**Shoreland Permit Application**for a **Shoreland Protection Permit** under  
Chapter 49A of Title 10, § 1441 *et seq.***For Shoreland Permitting Use Only**

Application Number: 268

Reference: **Richey Camp Addition, Danville, Vermont**

**From:** David Frothingham <David.Frothingham@dirtsteel.com>  
**Sent:** Thursday, March 31, 2016 11:52 AM  
**To:** Mitchell, Mark  
**Subject:** RE: Shoreland Permit Application #268, Richey  
**Attachments:** Shore land permit revised pages 2 & 3.pdf; C1.01 SITE PLAN r3-31-16.pdf

C:\jobfiles\16027 Richey Camp Office Addition\Civil\Drawing Files\16027 SP.dwg 9 Mar 2016 2:46 PM Rectburn

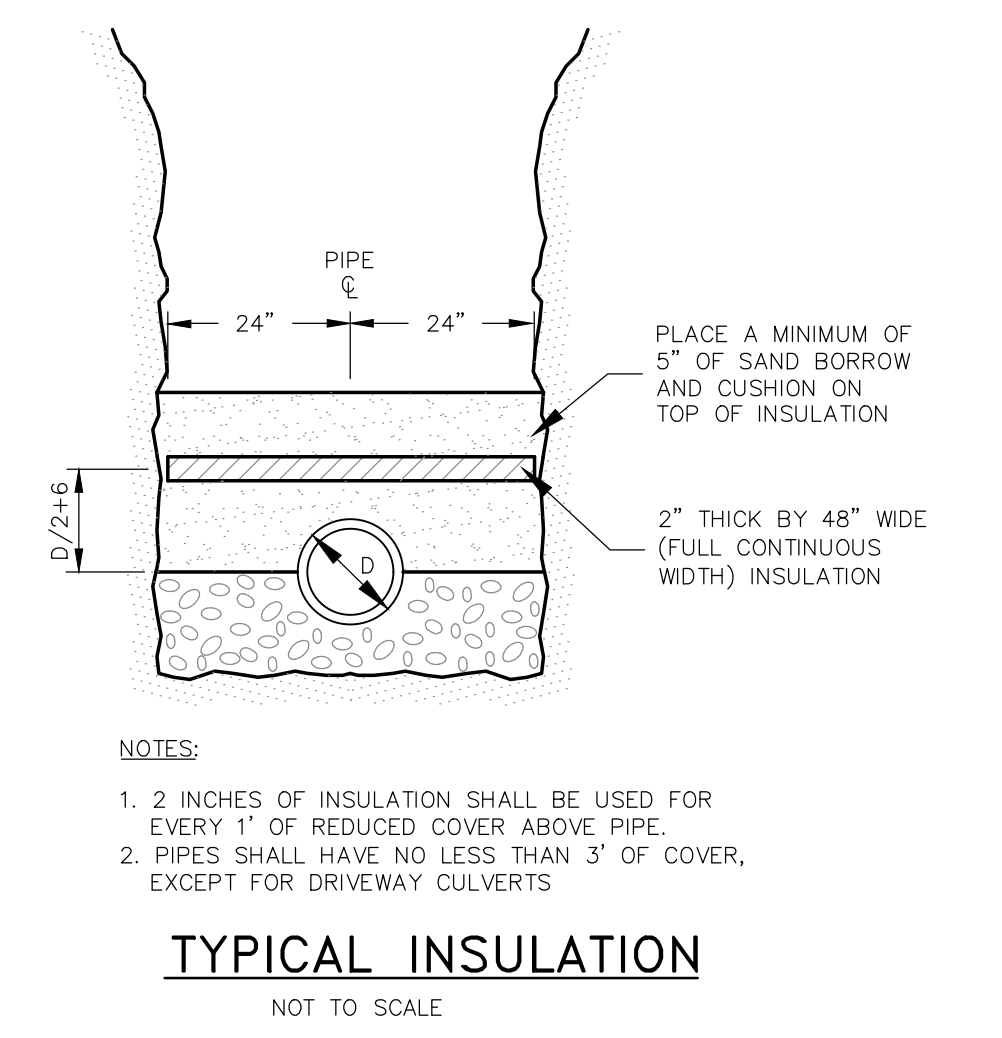
- 1) Section D.1 states that the new impervious area created will total 280 SF, but Section 5a states it will be 168 SF.
- 2) Section D.1 also states that the total cleared area on the property would be increased by 350 SF, but Section 6a states it will be 40 SF.
- 3) Section 6c must address the new cleared area through revegetation of an equal surface area within the same distance from mean water level.

REVISION	
		NO.	DATE
1	03/31/16	ADDED TREE PLANTINGS ALONG STREAM BANK	
<b>OFFICE ADDITION</b> 422 NORTH SHORE ROAD DANVILLE, VERMONT CHRIS BISSELL			
SHEET DESCRIPTION			
PROJECT NO.		DATE	
16027		9 MAR 2016	
SCALE		1"=5'	
DRAWN		C1.01	
RBC			
CHECKED		SHEET	
DLF		SHEET 2 OF 2

Please find attached the revised site plan and application pages. The applicate proposes to plant two maple trees along the top of bank of the adjacent stream. These trees will provide shade for the stream and the canopies, when grown, will exceed the 40sf required.
